1 Introduction

This document describes updates for the following default configuration:

EB00921 All information provided in this document is subject to legal disclaimers. © 2024 NXP B.V. All rights reserved.

Figure 1. PMC_LVD_MISC DCF record configuration

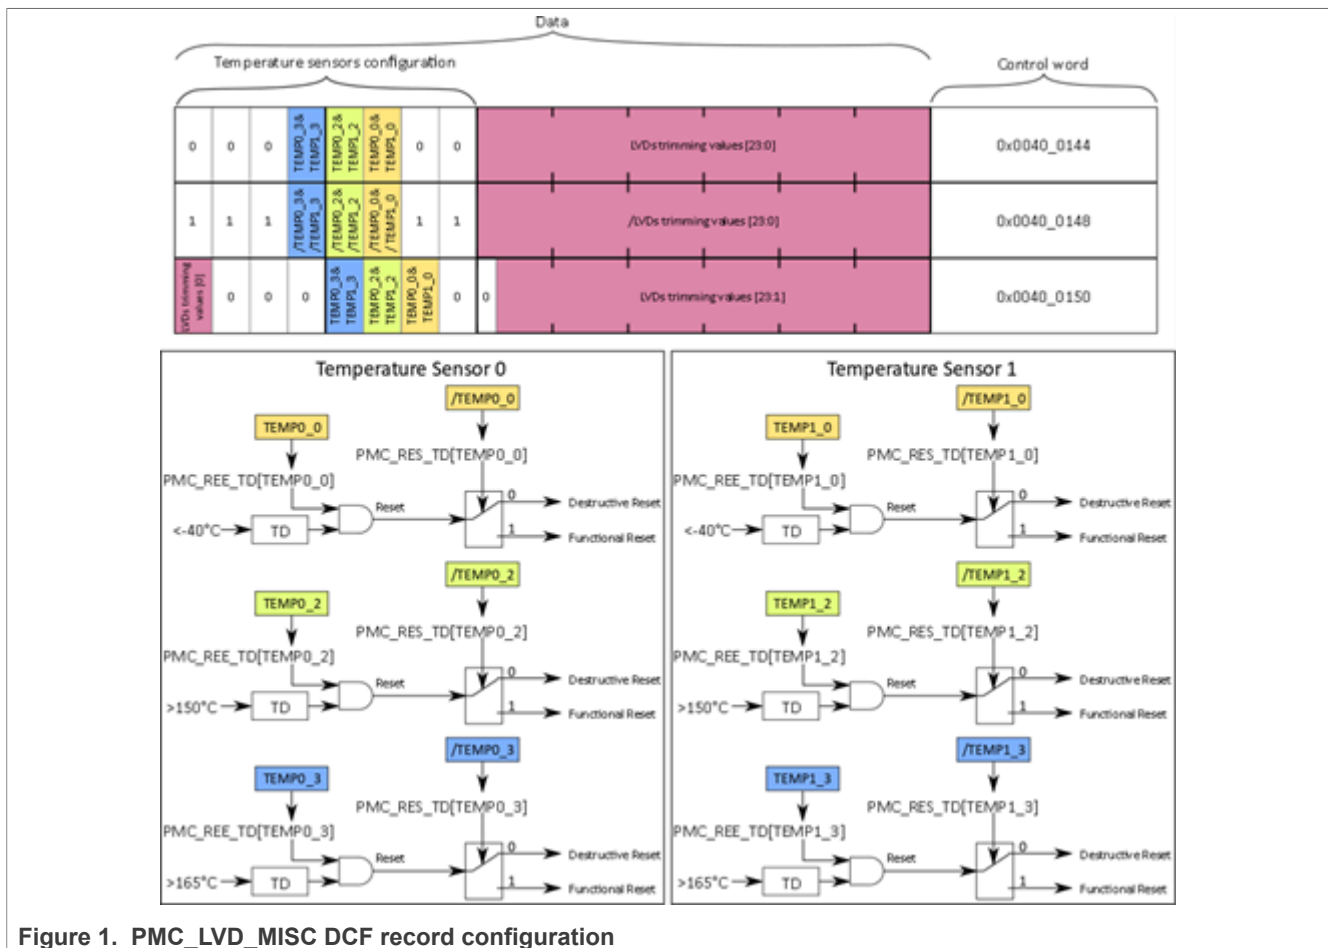
Storing the LVD trimming values into the utest flash memory on the address range 0x0040_00F0 – 0x0040_00FB.

The reason for this update is the possible usage of the PMC_LVD_MISC DCF record for configuration the temperature sensor reaction because this record configure together with the temperature sensor reaction also the LVD trimming values.

The PMC_LVD_MISC DCF record which programs the temperature sensor reset reaction and LVD trimming values are triple voting DCF record. It means that it is programmed by three record where the first content is the direct data, second is the inverted data and the third one is the rotated data. This is the reason why LVD trimming values are stored in this format in the utest flash. By default the temperature sensor reset reaction are disabled.
